Access Compliance Report

Public Rights-of-Way

(Curb Ramps)

Intersection ID: N/A	Main Street: WILLIAM CALDWELL AV	Cross Street: CALDWELL RD	Location: NE
ADA ID: E1C262B62846	Ramp Type: Combination2Diag	Initial Pass/Fail: Fail	Overall Compliance: No
Severity Score: 0			
Codes/Mitigation Info/Possible Solution		Field Measurements/Component Compliance

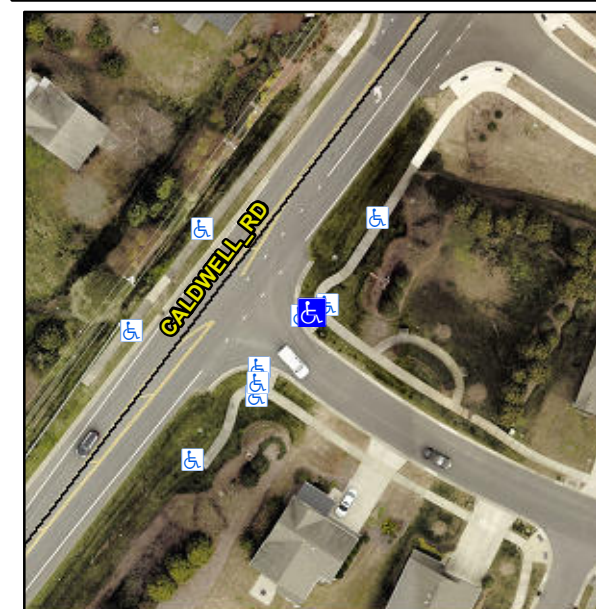
Not Found, R304.5.1, R304.5.3

Compliance	Description	Data	Compliance	Description	Data
N/A	Ramp Length LT (in)	20.0	N/A	Ramp Length RT (in)	14.0
Yes	Ramp Width LT (in)	59.0	Yes	Ramp Width RT (in)	61.0
Yes	Ramp Slope LT (%)	7.7	Yes	Ramp Slope RT (%)	1.3
No	Ramp XSlope LT (%)	2.9	Yes	Ramp XSlope RT (%)	1.7
N/A	Ramp Length (in)	98.0	Yes	Ramp Slope (%)	4.5
No	Ramp Width (in)	47.5	Yes	Ramp XSlope (%)	1.2
N/A	Flare Type LT	N/A	N/A	Flare Type RT	N/A
N/A	Flare Slope LT (%)	N/A	N/A	Flare Slope RT (%)	N/A
N/A	Flare Traversable LT?	N/A	N/A	Flare Traversable RT?	N/A
N/A	Landing Length (in)	N/A	N/A	DWS Provided?	N/A
N/A	Landing Width (in)	N/A	N/A	DWS Contrast?	N/A
N/A	Landing Slope (%)	N/A	N/A	DWS Length (in)	N/A
N/A	Landing X Slope (%)	N/A	N/A	DWS Full Width?	N/A
N/A	Landing Curb? (Y/N)	N/A	N/A	DWS Offset (in)	N/A
N/A	Shared Landing?	N/A			
N/A	Gutter Ponding?	N/A	N/A	Gutter Slope (%)	N/A
N/A	Gutter Lip Ht (in)	N/A	N/A	Gutter X Slope (%)	N/A
N/A	Painted X Walk1?	No	N/A	Painted X Walk2?	No

Remove & Replace Curb Ramp With Two New Directional Ramps or Equivalent.
